**PILOT STUDY
UIC CLASS V
WELL**

From: Tsinnajinnie, Leona, NMENV
Sent: Monday, November 18, 2019 5:09 PM
To: Jason.Leik@HollyFrontier.com
Cc: Cobrain, Dave, NMENV; VanHorn, Kristen, NMENV; Suzuki, Michiya, NMENV; Griswold, Jim, EMNRD; Chavez, Carl J, EMNRD; Holder, Mike; Scott M. Denton (scott.denton@hollyfrontier.com); Combs, Robert (Robert.Combs@hollyfrontier.com); JSpeer@trccompanies.com; SBrimo@trccompanies.com
Subject: RE: HollyFrontier Navajo Refining LLC - Groundwater and Phase-Separated Hydrocarbon Recovery System Enhancements - Revised Pilot Test Locations EPA ID No.NMD048918817 HWB-NRC-19-002

**RE: APPROVAL
EXTENSION REQUEST FOR SUBMITTAL OF THE REVISED GROUNDWATER
AND PHASE-SEPARATED HYDROCARBON RECOVERY SYSTEM ENHANCEMENTS:
REINJECTION PILOT TEST WORK PLAN
HOLLYFRONTIER NAVAJO REFINING LLC, ARTESIA REFINERY
EPA ID NO. NMD048918817
HWB-NRC-19-002**

Re: Response to Comments to the July 22, 2019 Letter of Disapproval, *Groundwater and Phase-Separated Hydrocarbon Recovery System Enhancements: Reinjection Pilot Test Work Plan*
HollyFrontier Navajo Refining LLC, Artesia Refinery
EPA ID No. NMD048918817
HWB-NRC-19-002

FIGURE 3 - HISTORICALLY DEPRESSED
SULFATE CONCENTRATIONS, NMED
JULY 22, 2019 LETTER, COMMENT 5b

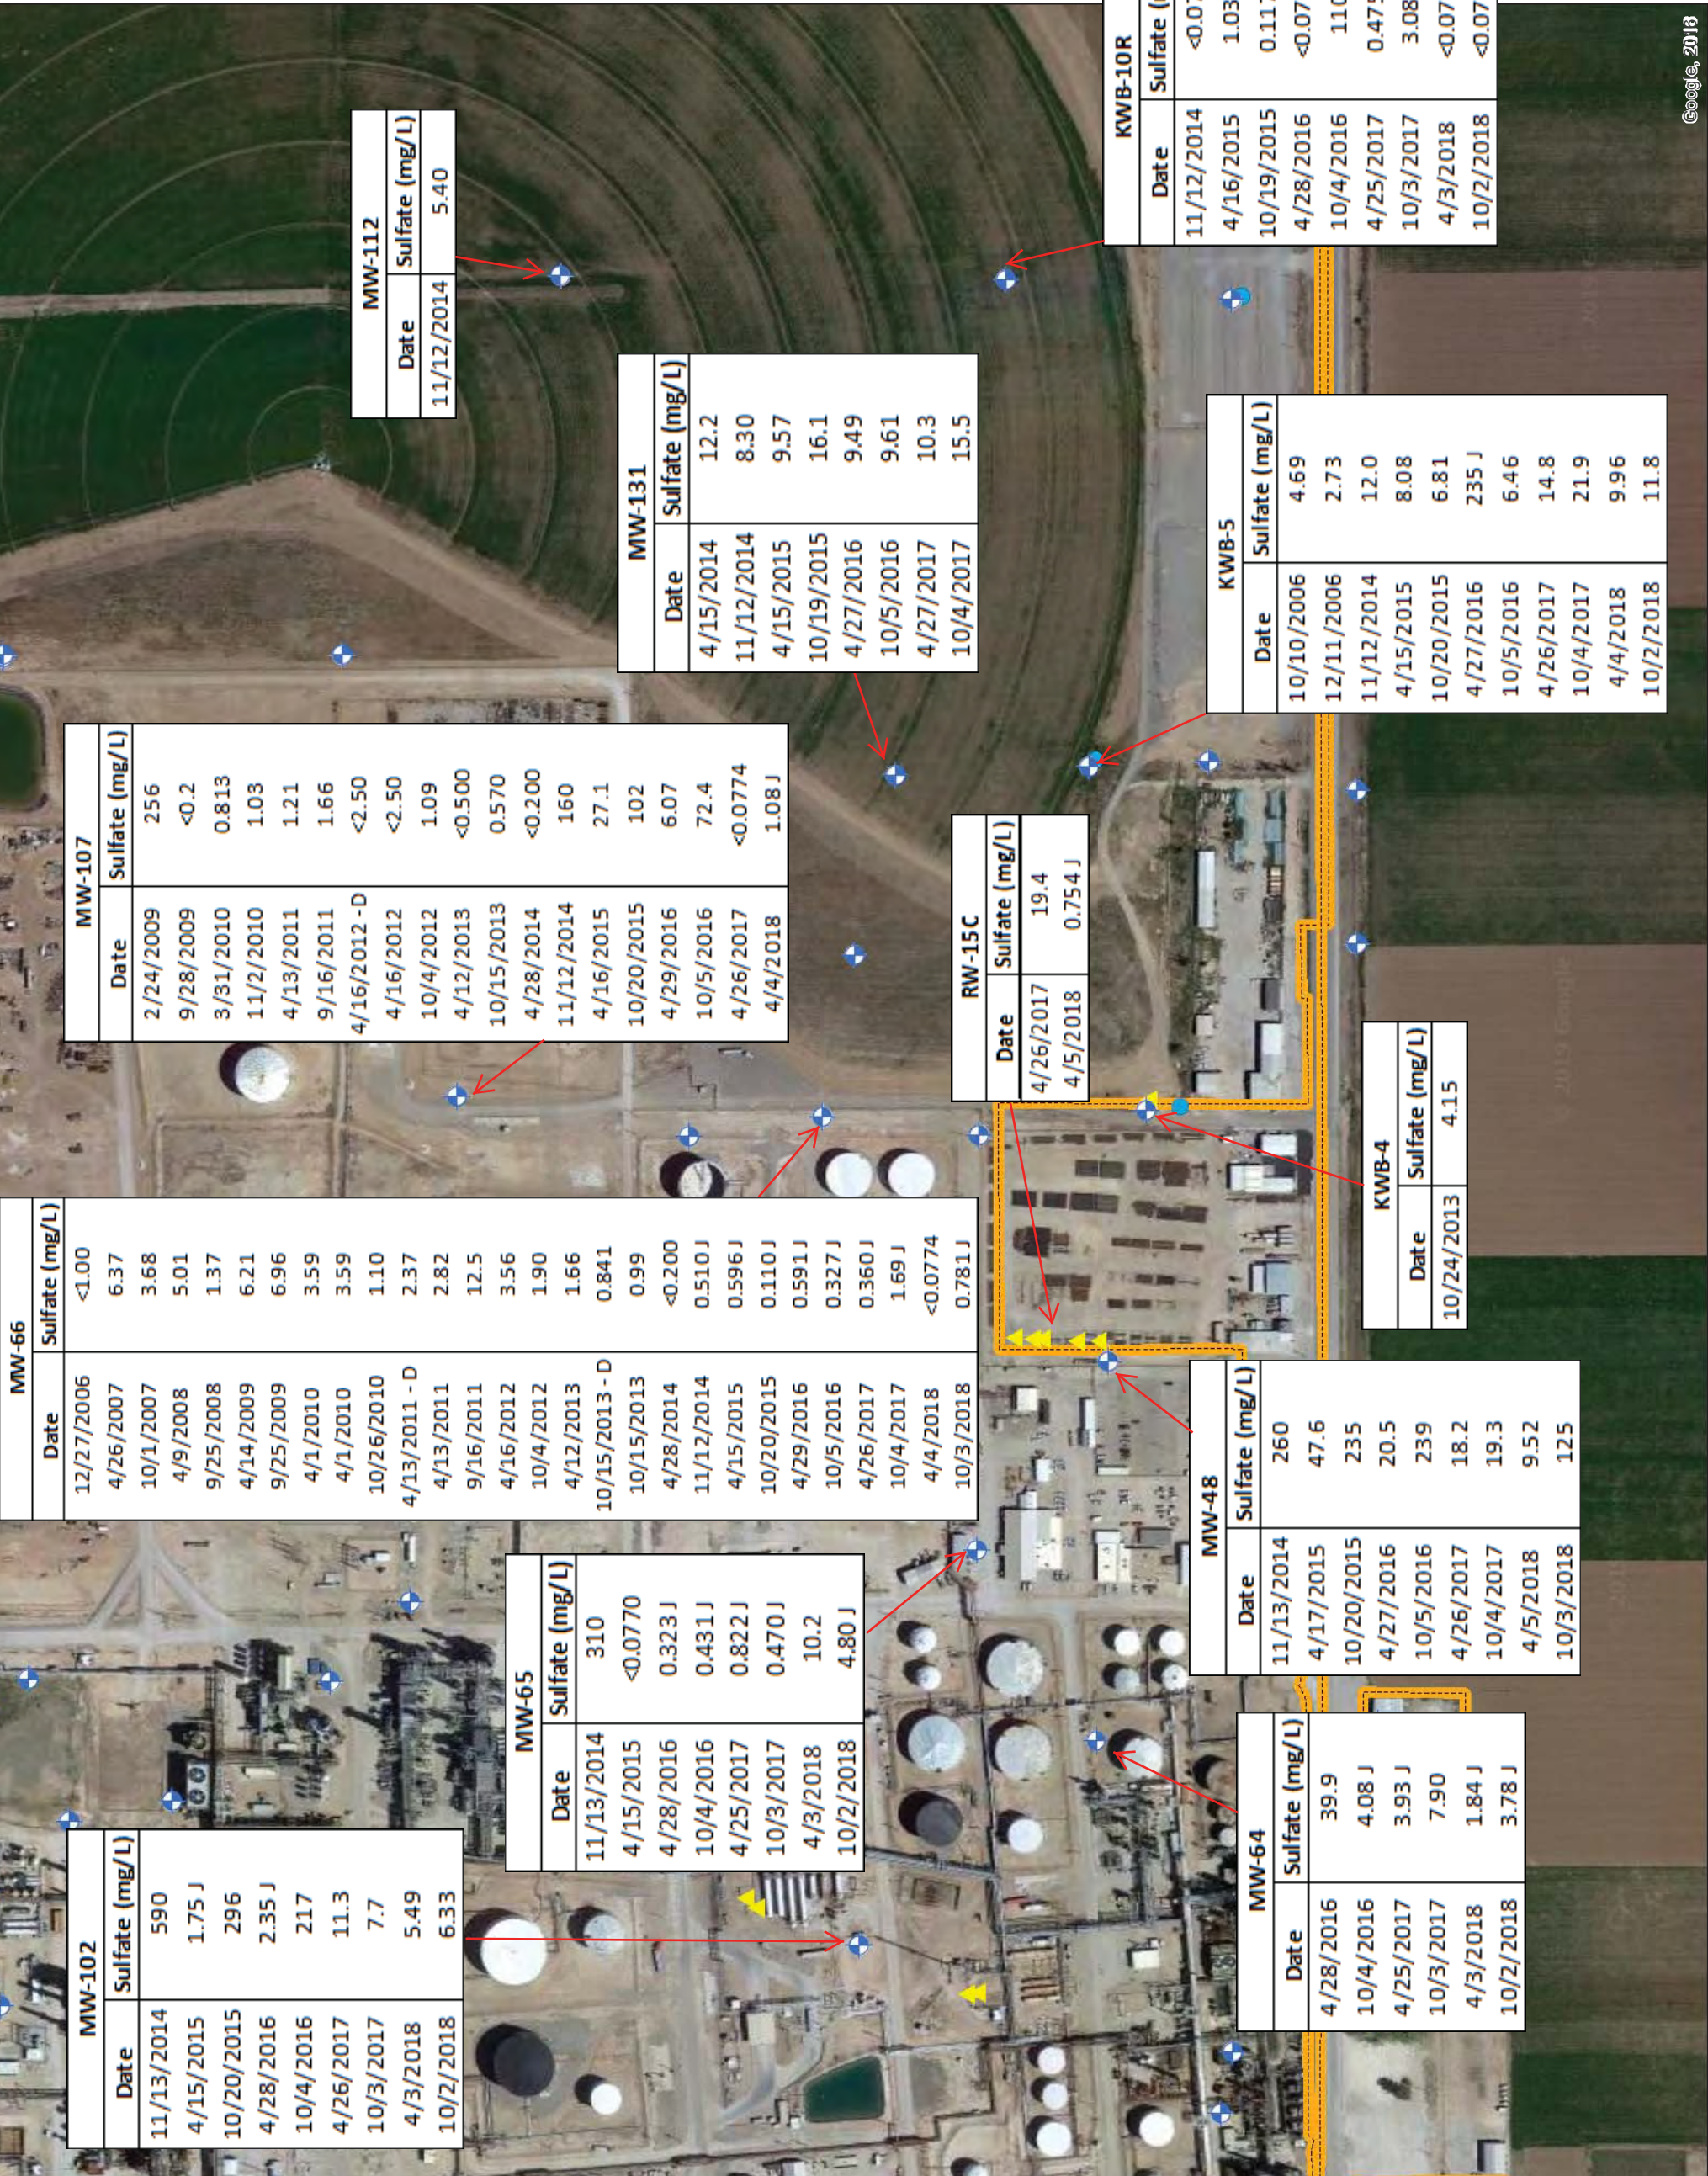
- b. Regarding the perspective that sulfate concentrations in MW-131 are “exceptionally low compared to other wells in the vicinity,” HFNR provides the following further information: sulfate concentrations are depressed within the dissolved hydrocarbon plume across the southern refinery, as shown on Figure 2. Historical sulfate concentrations in wells MW-48, MW-64, MW-65, MW-66, MW-102, MW-107, KWB-5, KWB-10R, and RW-15C are generally consistent with or less than the noted sulfate concentrations in MW-131 as shown on Figures 2 and 3. Further, sulfate has either not been detected or detected at low estimated J-flag concentrations in some of these wells during recent groundwater monitoring events.

FIGURE 3: PROCESS AND INSTRUMENTATION DIAGRAM
SULFATE AND AMMONIA INJECTION

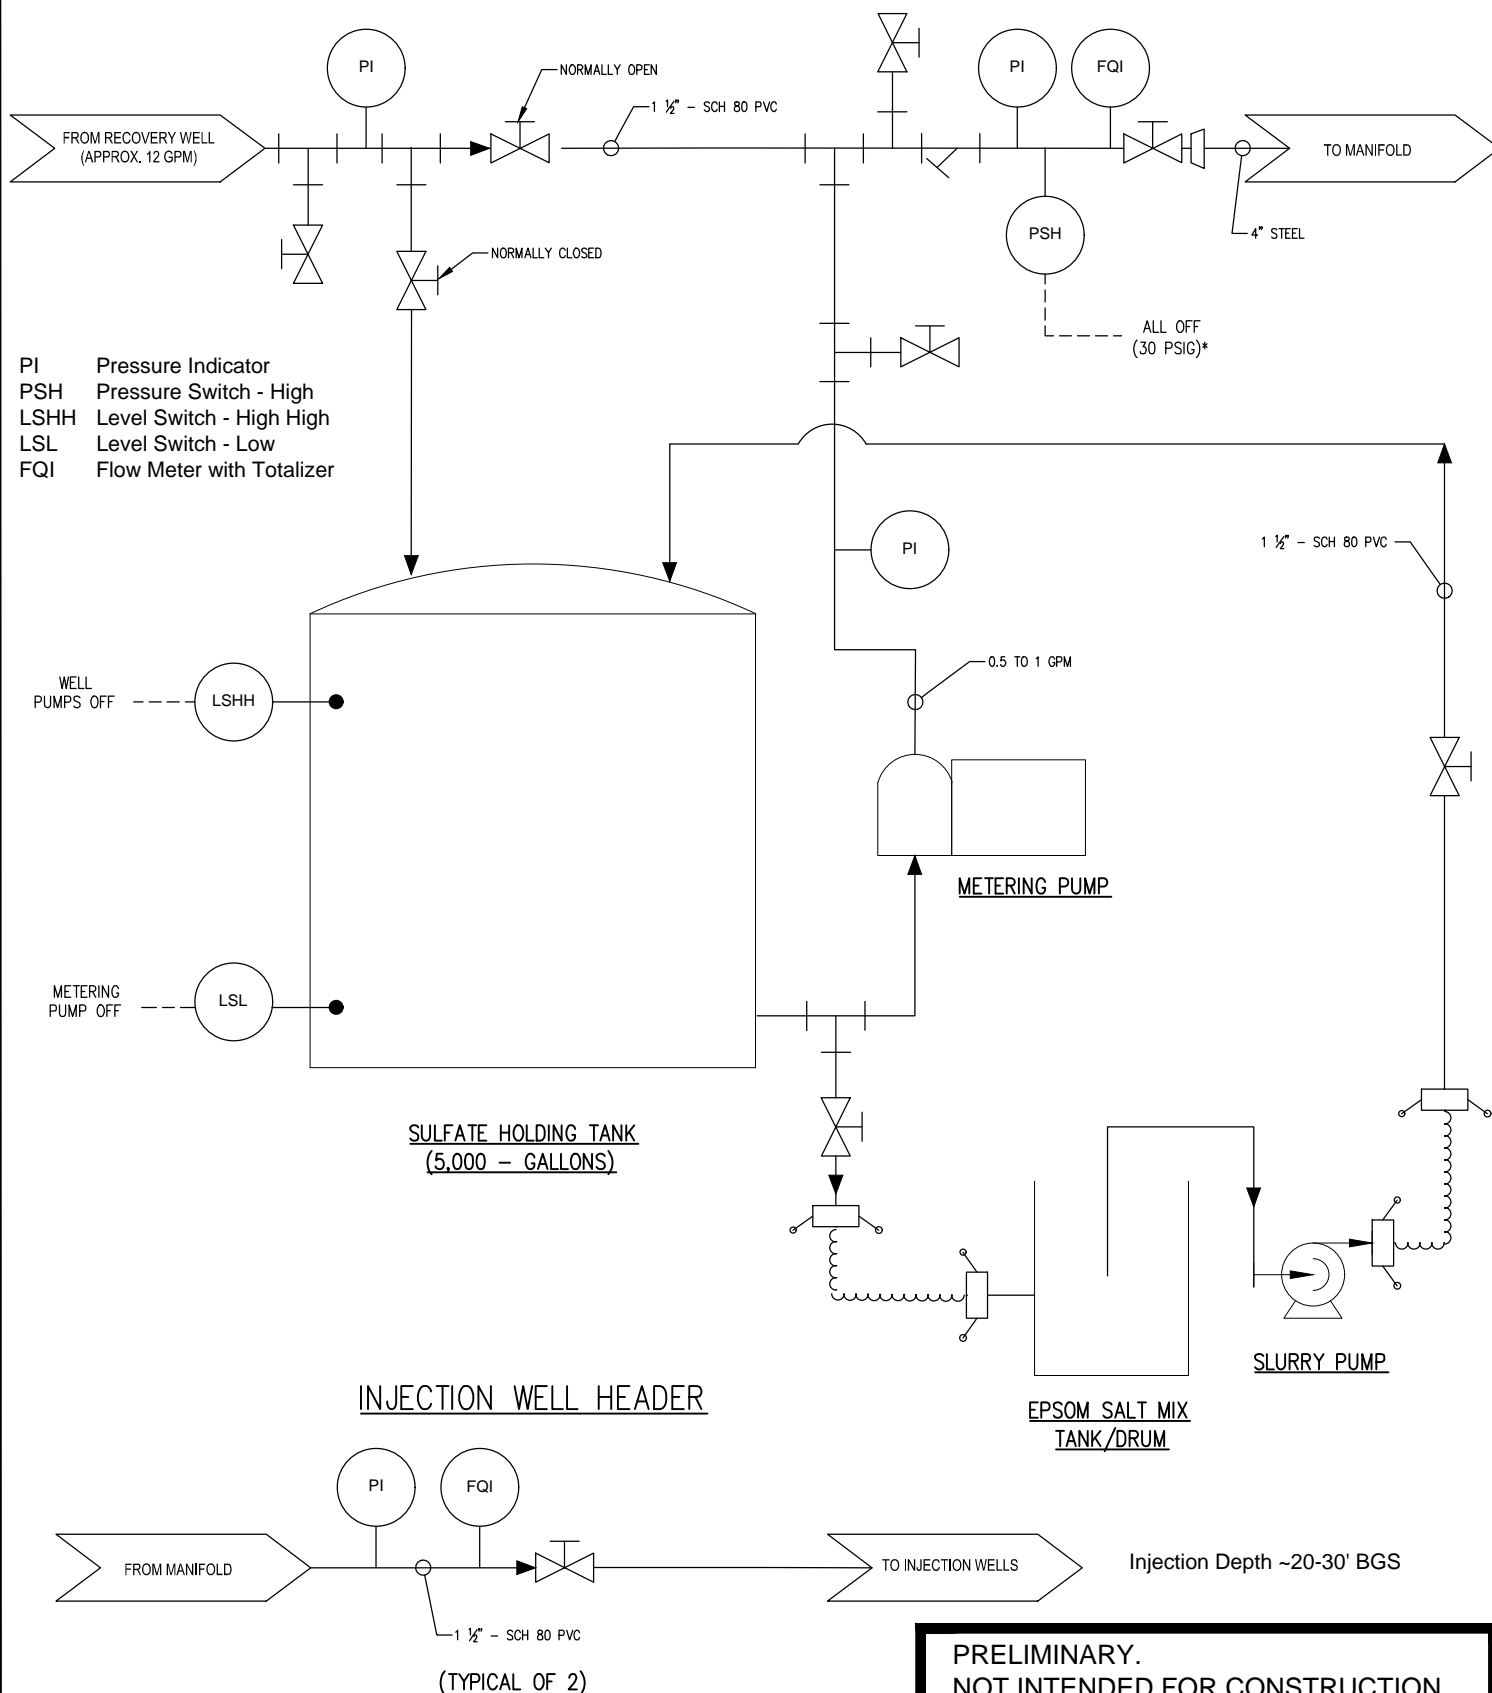
retained in the separation tank with enough retention time to separate PSH by gravity; then, only the aqueous solution from the bottom of the tank can be transferred to the mixing tank. Revise Figure 3 to depict (1) where the tote(s) will be located, (2) if piping will be run from the wells to the tote(s) for PSH recovery, (3) location of individual tanks to separate water and PSH and mix the amendments, (4) a skimmer pump that removes PSH from the retention tank, if any, and (5) discuss and illustrate measures to provide adequate mixing for the amendments.

- a. *The Permittee did not state if the extracted groundwater will be treated to meet groundwater standards prior to injection. Revise Section 5.2.3 to clarify if the extracted groundwater will be treated prior to injection and what method will be used to treat it. Also, modify Figure 3 to include the measures, if any.*

the PSH recovered volume will be recorded; however, Figure 3 does not depict any mechanism to remove PSH (e.g., oil-water separator). Include the provisions in the revised Work Plan. Additionally, discuss specific measures that will prevent the extracted groundwater from being aerated in the recirculation process in the revised Work Plan.

See Response 1 and 17. The injection criteria of the Pilot Test and full-scale system is to remove PSH (if present) and add amendments (terminal electron acceptors) to reduce hydrocarbons in situ by EAB. PSH will be removed as necessary with an OWS prior to recirculation of the extracted water. PSH will not be allowed to enter the amendment tank(s). Figure 3 of the Work Plan will be revised to show how PSH will be managed.
